Department of Energy
Richland Operations Office
P.O. Box 550
Richland, Washington 99352

NRC REQUEST FOR CLARIFICATION OF BWIP SCR

FIGURE 18-1. Basalt Waste Isolation Project Management Organization.

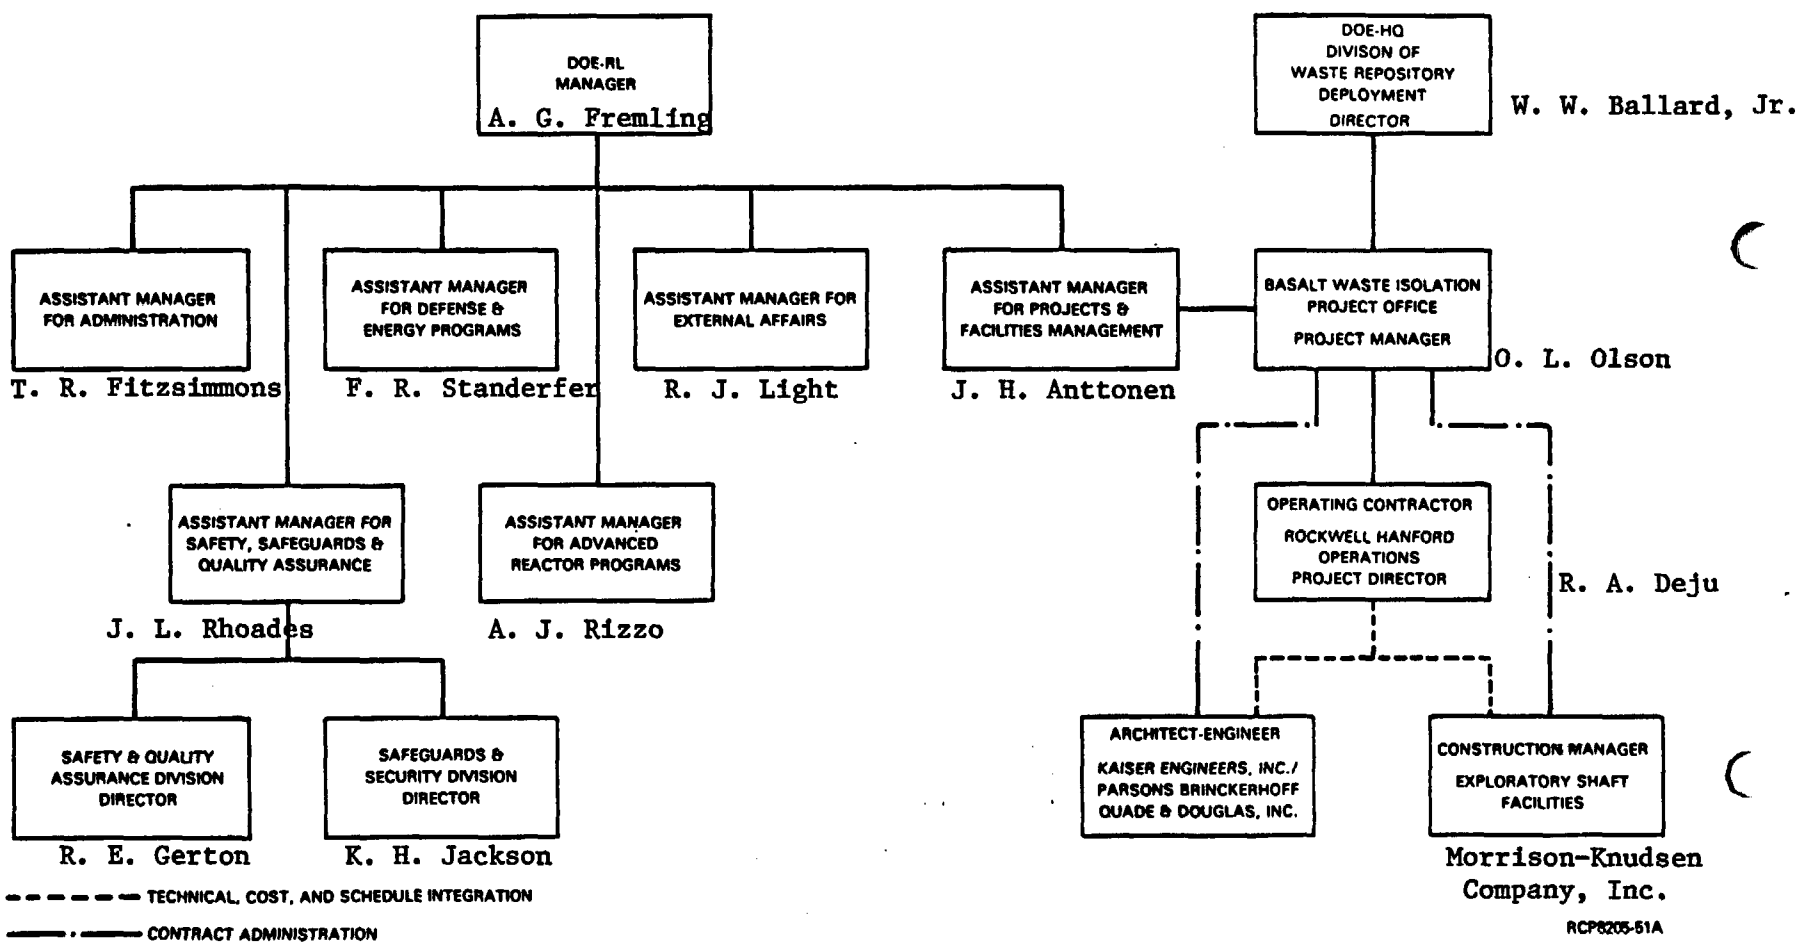
Please identify the individuals who occupy the positions listed in Figures 18-1, 18-2, and 18-3 of the SCR.

A copy of Figures 18-1, 18-2 and 18-3 of the SCR is enclosed, with the names of the individuals who occupy the positions typed in or near the appropriate box. However, since the BWIP SCR was furnished to you in November 1982, the Rockwell Basalt Project office has been reorganized as shown on Attachment I. In future updates of the SCR, Figure 18-3 will be revised to reflect this change.
